3400 + 3428 Woodroffe Avenue

Urban Design Brief
December 2, 2025

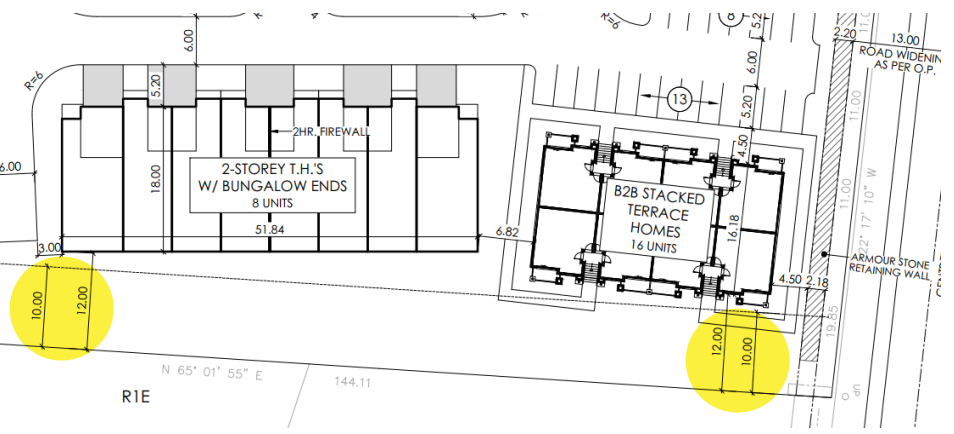
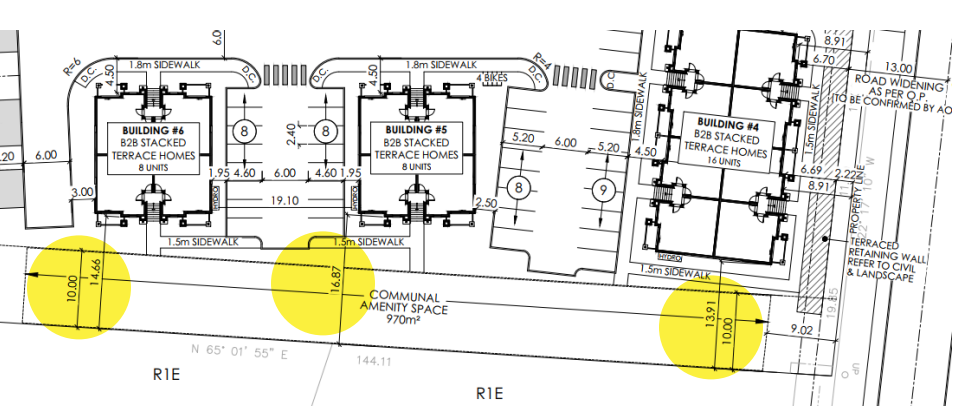
2. The intention for the 10m landscape buffer along the southern property line is to retain trees vs. for it to be private amenity space. Where will private amenity space be provided for these units along the southern property line? An increased setback to provide rear yards for these units, and increased setback to stacks to accommodate the proposed walkway should be provided.

An increased setback between the back-to-back stacked terrace homes and the southern property line has been provided. In the original pre-consultation submission, the walkways extended into the 10-metre buffer and the building itself was set back 12 metres:

In the current concept, the stacked back-to-back terrace home has been rotated so that it faces Woodroffe Avenue and the sidewalk no longer extends into the 10-metre buffer. As well, the two (2) storey townhouses have been replaced with two (2) stacked back-to-back terrace homes, both of which have walkways that do not extend into the buffer. Setbacks to the property line have been increased from 12 metres for the townhouses to 14.66 and 16.87 metres for the stacked back-to-back terrace homes that replaced them, and increased from 12 to 13.91 metres for the southeastern stacked back-to-back terrace home:
